KENETECH/PacifiCorp Windpower Project **Environmental Impact Statement**

FINAL ENVIRONMENTAL IMPACT STATEMENT KENETECH/PACIFICORP WINDPOWER PROJECT CARBON COUNTY, WYOMING

This abbreviated Final Environmental Impact Statement (FEIS) on the Kenetech/Pacificory Mindpower Project, located in eastern Carbon County, Wyoming, is provided for your information and use. This FEIS is a supplement to the Draft Environmental Impact Statement (DEIS), published in January 1995. The FEIS incorporates by reference the material presented in the DEIS and identifies changes to the DEIS as a result of additional information and public comments ubsequent to the publishing of the DEIS. It also contains comments received on the DEIS and responses to those comments. The DEIS was not reprinted as an economy measure. Changes made to DEIS materials do not significantly after the proposed action or outcome of the analysis. The DEIS must accompany this final document because only the modification, corrections, and additions are provided.

Figure 2.1 Flow Chart Showing Environmental Review Process and Agency and Public Consultation.

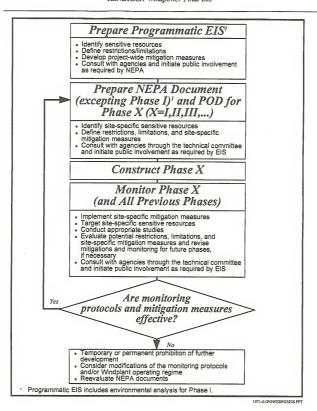
Page 2-7, Figure 2.1. Replace Figure 2.1 in the DEIS with Figure 2.1 in the FEIS.

- Page 2-7. Figure 2.1: Any additional mitigation measures that might be required in PODs should be included as contingencies in the ETS along with meaningful criteria for monitoring effectiveness. Such criteria have not been provided for in the DETS.

$\label{eq:map_proposed_locations} \begin{tabular}{ll} Map 2.1 & Proposed Locations of Turbine Strings and Access Roads for the First Phase of Windplant Development on Foote Creek Rim. \\ \end{tabular}$

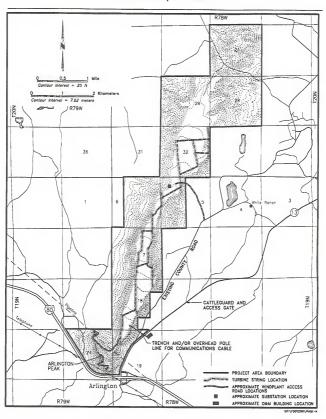
Page 2-6. Replace Map 2.1 in the DEIS with Map 2.1 in the FEIS.
